APPLICATION NO.	FILING DATE	FIRST NAMED INVENTOR	ATTORNEY DOCKET NO.	CONFIRMATION NO.
10/510,838	05/18/2005	Emil Edwin	0001885USU/3053	3864

**Advisory Action  
Before the Filing of an Appeal Brief**

THE REPLY FILED 06 February 2007 FAILS TO PLACE THIS APPLICATION IN CONDITION FOR ALLOWANCE.

Fig. 1

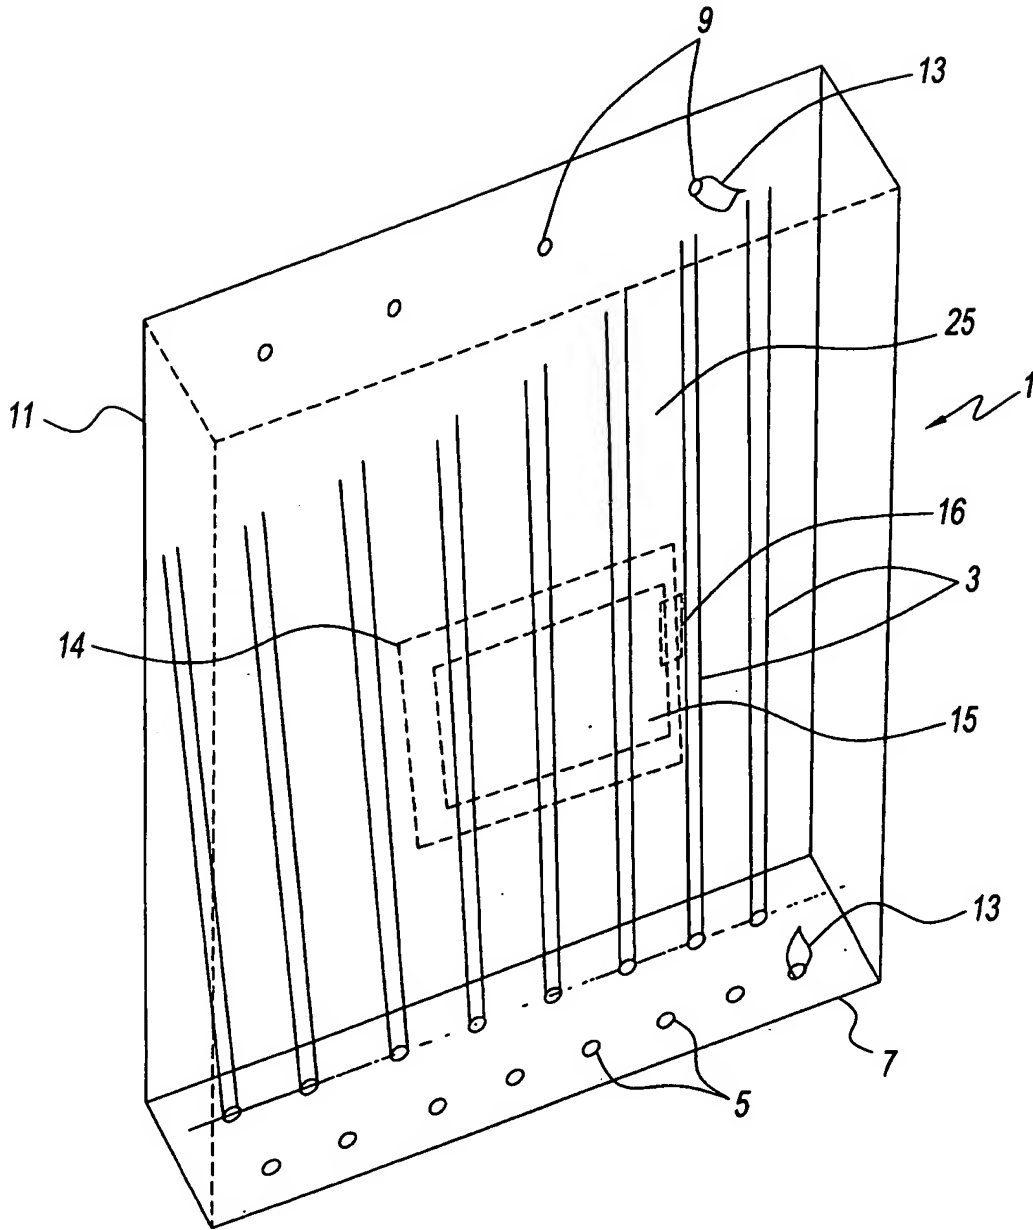
Approved  
3/1/07

Fig. 2

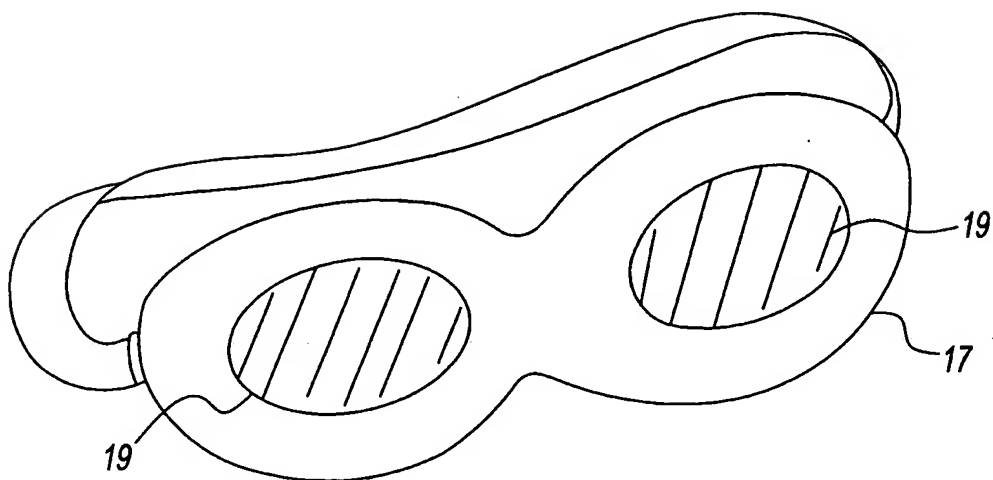
Approved  
3/1/07

Fig. 3

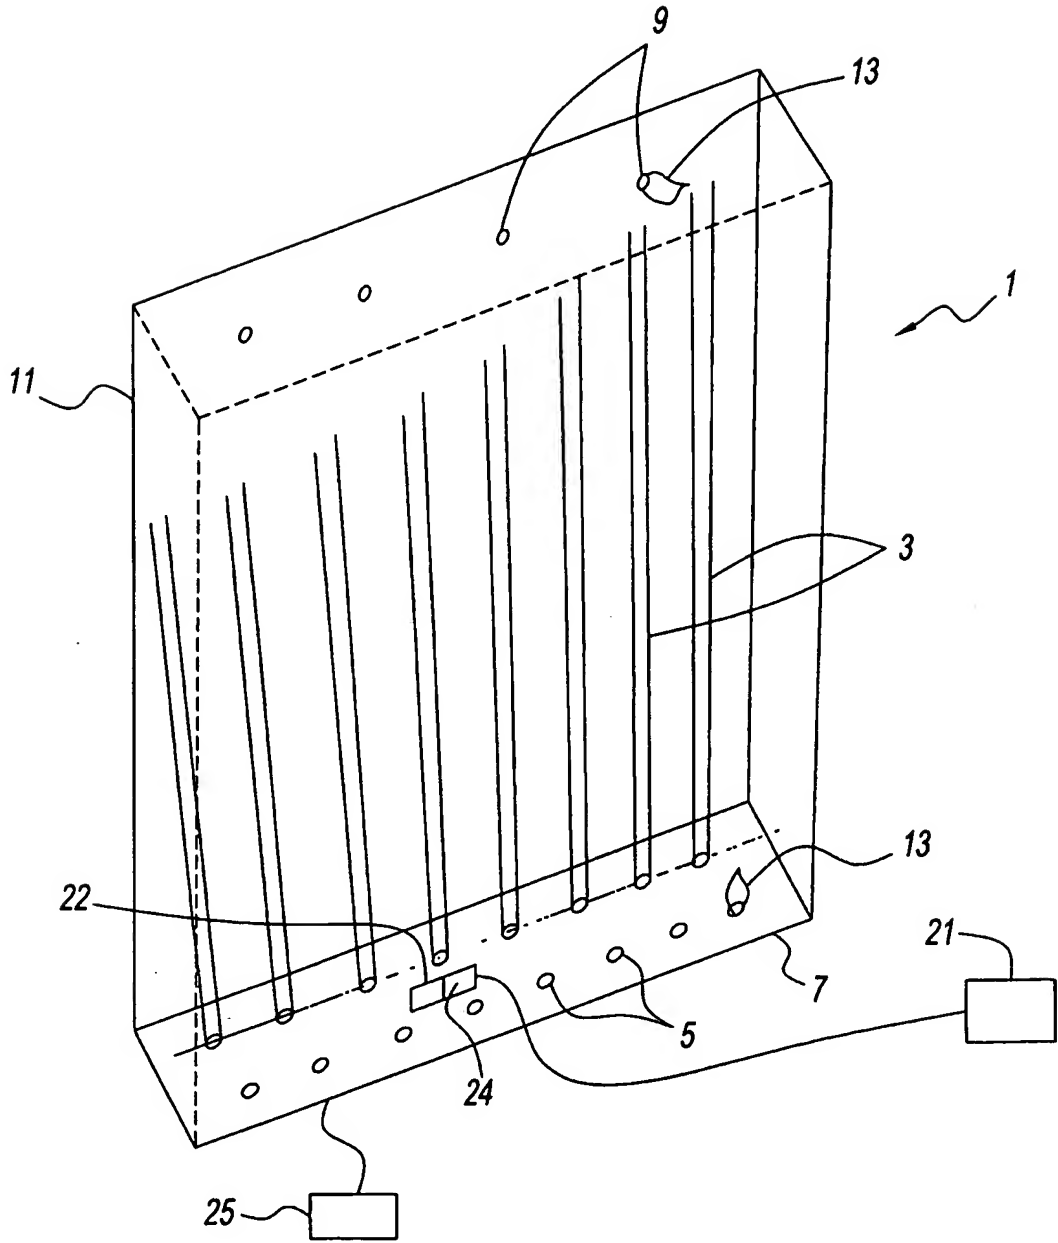
Continuation of 3. NOTE: New issues requiring further consideration and related to issues of new matter include at least the proposed changes to the Drawing figures submitted in the Replacement Sheet 3. For example, it is noted the specification as originally filed lacks support for the means for relaying, monitoring and adjusting (21, 25) being in the form requiring a physical wire or line connection in the manner illustrated.

not recommended  
3/1/07
